### DEVELOPMENT REVIEW COMMENTS 17-01

SUBJECT: MacDonnell Heights Town Center

I have completed my review of the MacDonnell Heights Town Center and I would recommend that the proposed developer consider the following conditions within the project:

**Figure 8. Parallel Bus Bay**

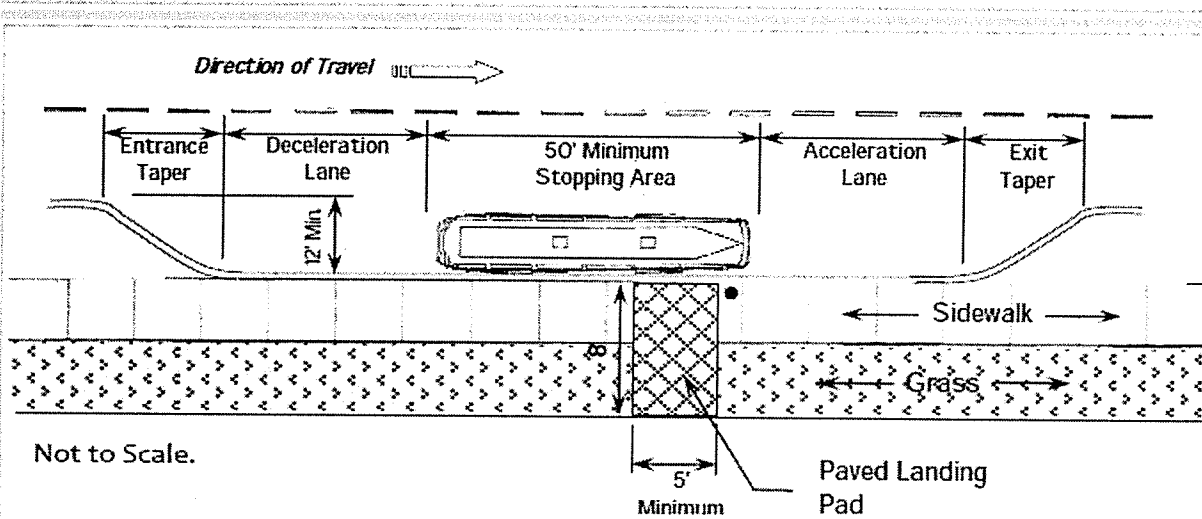
- On both sides Dutchess Turnpike, to include a bus shelter with trash receptacle, bench, map case and solar powered lighting in the turnout near Buildings E and H.
- A pole should be placed to allow for placement of a bus stop sign which would be attached by the County.
- The bus turnout should follow the specifications as defined below to ensure that a 40 foot bus can enter and exit the turnout safely.
- This project is served by Dutchess County Public Transit Route D, Monday through Saturday.
- There should be sidewalk access along Dutchess Turnpike from Barnes Drive to Victory Lane and Darrow Place to Concord Village Drive with curb cuts that meet Americans with Disabilities Act (ADA) requirements.
